MOTORCYCLE DOCTOR LLC

UTV500 Cylinder Body 12100-004-0000 Changed for 2015 and newer ?

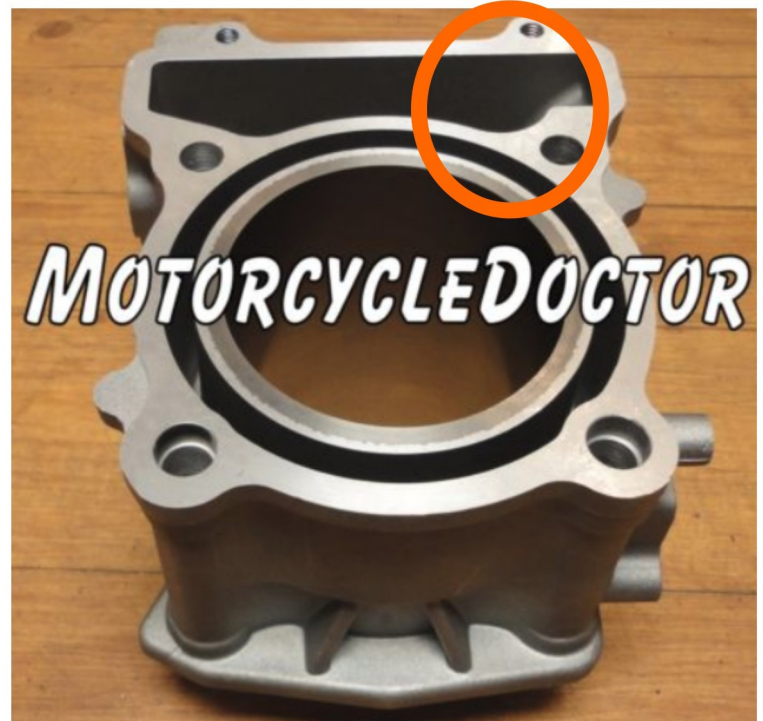
New

Missing Side Rubber

Old

Tensioner Guide 14520-004-0000

Is also different, Old side pad is too wide.
